ERC03000 - Efficient management of system strength on the power system

Table 1 Response to Draft Determination (Demand Side)

Figure 1 Variation in SCR at POC vs Terminals for two different Generating Systems¹

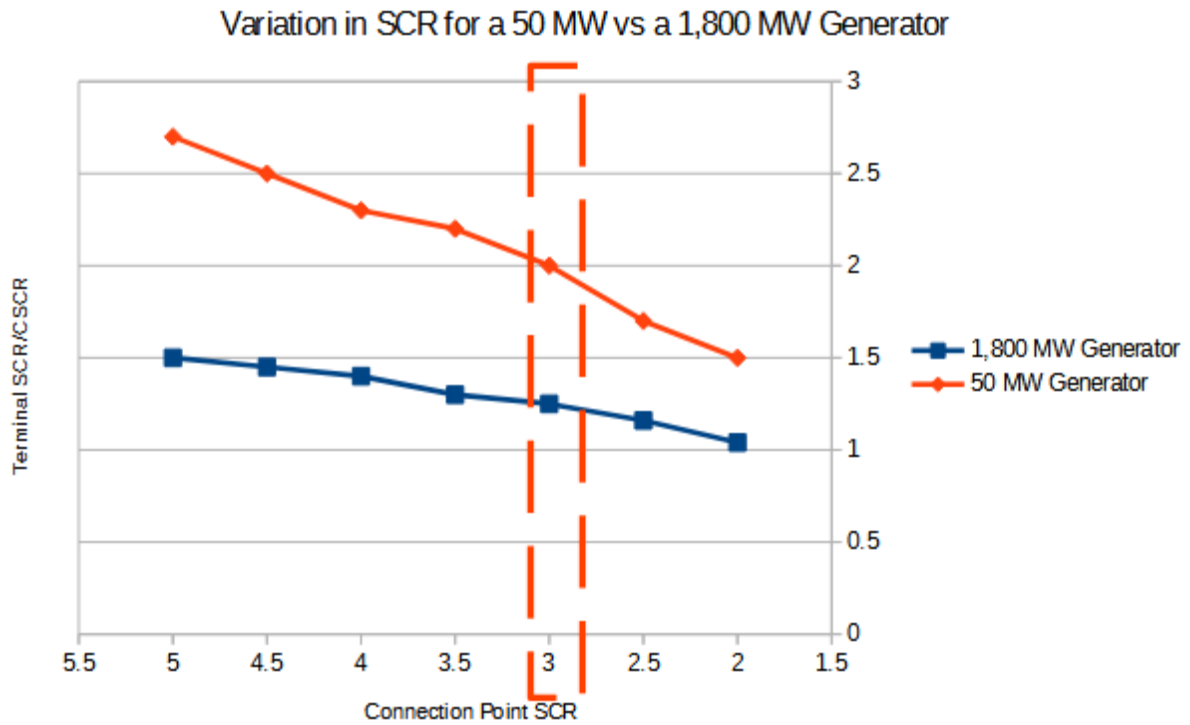
Item	Reference	Comments	Recommendation
SCR definition at IBR terminals	Draft rule glossary	SCR being defined at the connection point will penalise IBRs part of a larger generating system as these would have a much higher (balance of plant) impedance between the connection point and IBR terminals (regardless of the IBR OEM and inverter model). Selection of IBR to operate down to low levels of system strength should be based on the IBR capability alone and not the balance of plant impedances.	Change reference to connection point to IBR terminal in the definition of Short Circuit Ratio.
SCR of 3.0 at the connection point is not workable	S5.2.5.15 (b)	Draft rule clause S5.2.5.15 (b) states a Minimum Access Standard (MAS) for SCR of 3.0 at the connection point. Where this SCR cannot be met, the generator would be prevented from connecting due to inability to meet the MAS. The draft rule as it stands is not workable as the actual SCR at the IBR terminal (and hence ability to operate stably) is a function of the balance of plant impedance which is directly related to the MW size of the Generating System. Refer Figure 1 below where the SCR at the IBR terminal (even if the same OEM and IBR model), would be vastly different across projects due to the different Balance of Plant impedances. On large projects connecting to weak networks, the only solution would be to install a synchronous condenser (electrically) close to the IBR terminals (withing the generating system) and the draft rule would preclude this from occurring.	<ol style="list-style-type: none"> 1. It is recommended that the SCR of 3 (or a lower reasonable number) be applied at the IBR terminals. 2. To the extent the SCR is defined at the connection point, the use of synchronous condensers within the generating system (or similar) should not preclude compliance with this new access standard. For large projects, this would be the only way to operate the IBR stably. Refer Figure 1 and the associated reference for further information. Note that this is based on actual NEM connected project information.
